| Title | Comments on AWD Downlink Physical Structure | |
| Date Submitted | 2009-07-06 | |
| Re: | 802.16m amendment working document "Comments on AWD 15.3.5 Downlink Physical Structure" | |

Figure 462—Pilot patterns for 8 data streams

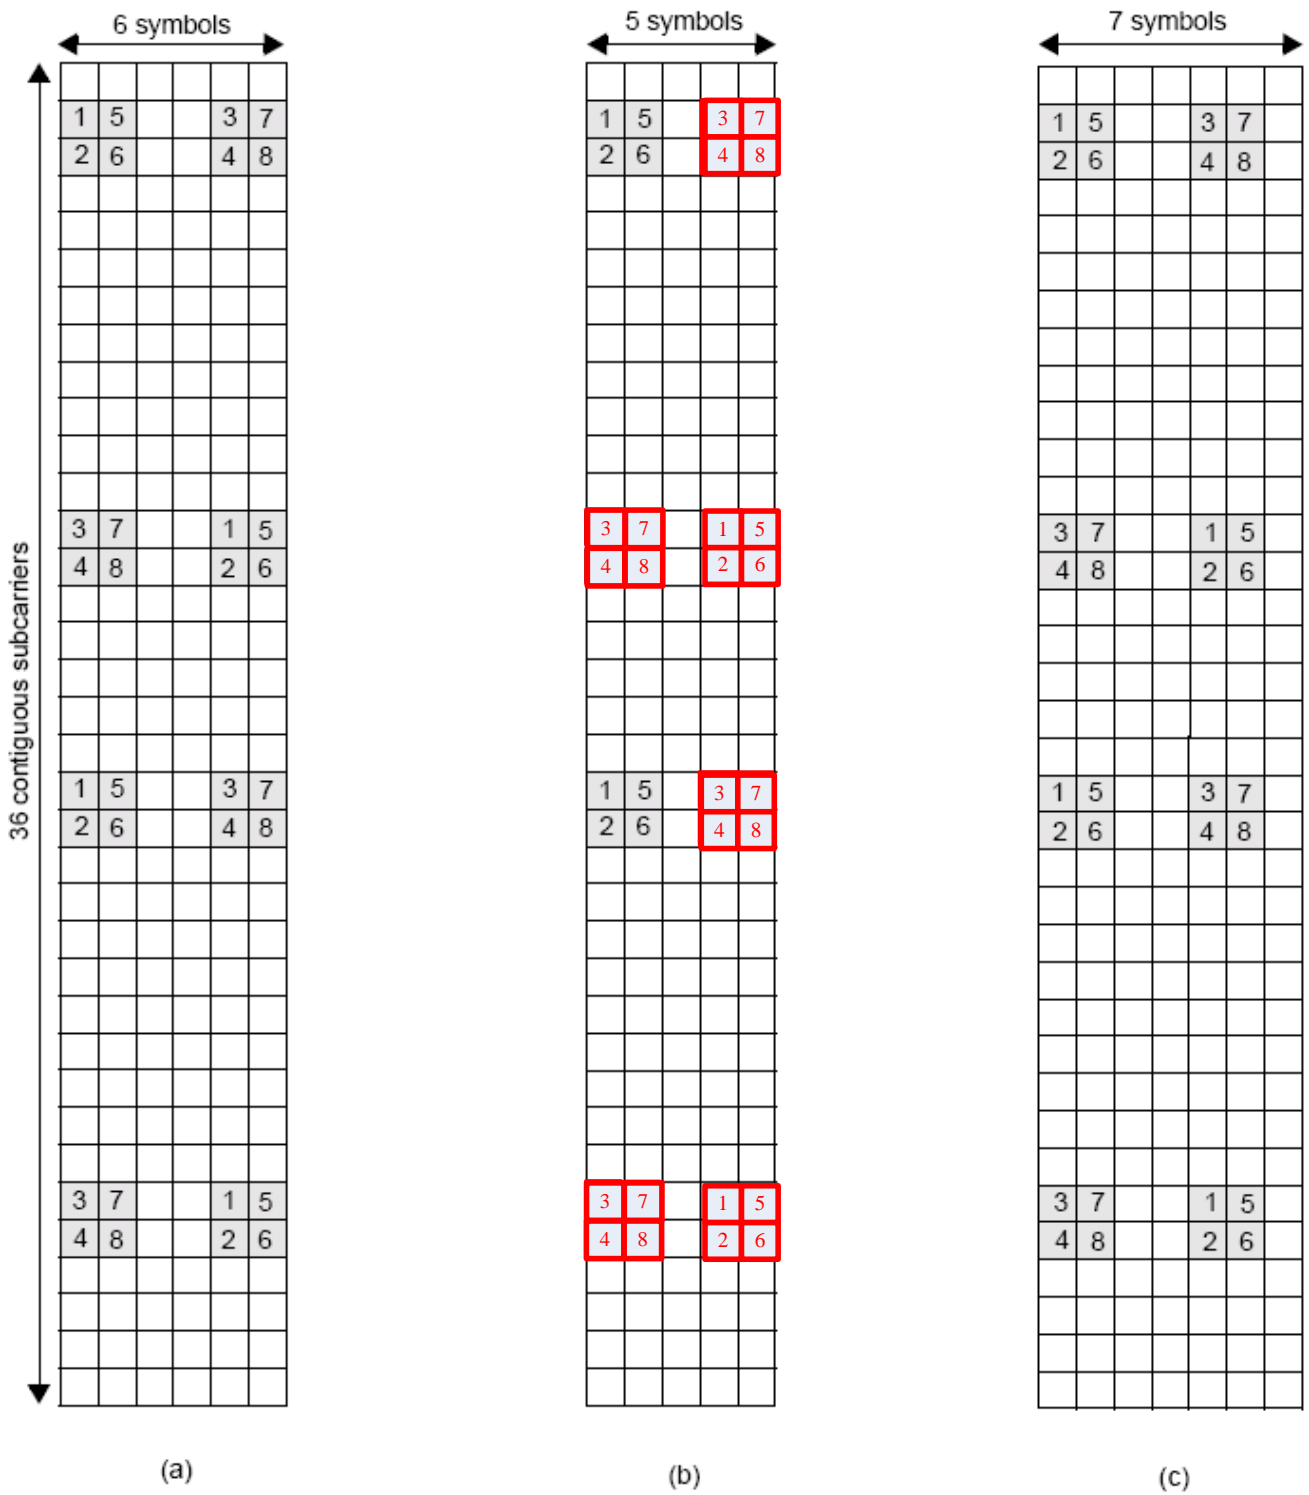
This contribution provides the corrected AWD text proposal to Pilot Patterns. In Figure 462, it has some errors in the entries and needs correction.

[In IEEE 80216m-08_0010r2, Section 15.3.5.4.1, replace the original Figure 462 by the following modified figure.]
